OMRON

NO: **TC-007**
Date: **September 2001**

The E5EX Temperature Controllers will be Discontinued in March 2003

E5EX & E5EK Dimensions & Characteristics

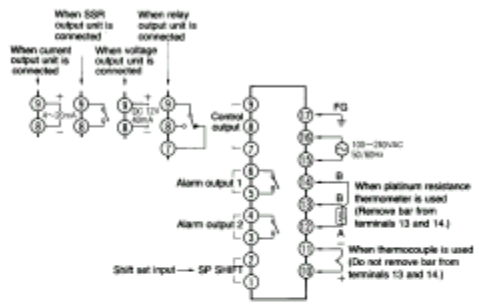
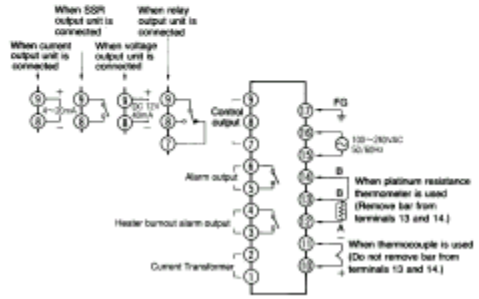
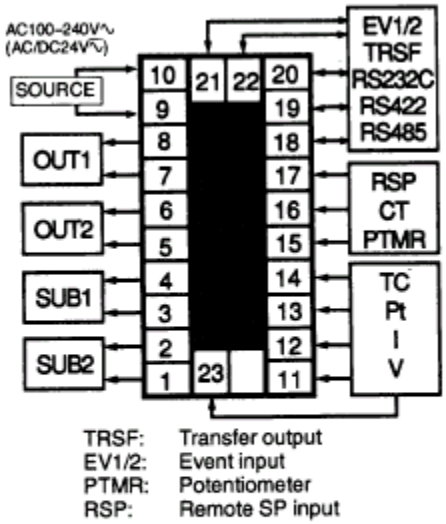
The E5EK is the best possible solution for the E5EX temperature controller. Some of the key differences between the two series are the wiring, color of unit, exposed control panel, and panel cutout size. When assisting your customers in converting their current drawings from E5EX to the E5EK be sure to advise them that the E5EK is a more diverse product due to the abundance of output boards available.

Model to be discontinued E5EX (basic type)	Recommended replacement model E5EK
Panel Cutout  **Side-by-side Mounting of N Controllers**  $L = (48N - 2.5)^{+1}_{0}$	**Panel Cutouts**  **Note:** 1. Recommended panel thickness is 1 to 8 mm. 2. Maintain the specified vertical and horizontal mounting space between each Unit. Units must not be closely mounted vertically or horizontally.

Model to be discontinued E5EX (basic type)	Recommended replacement model E5EK
Dimensions	Dimensions
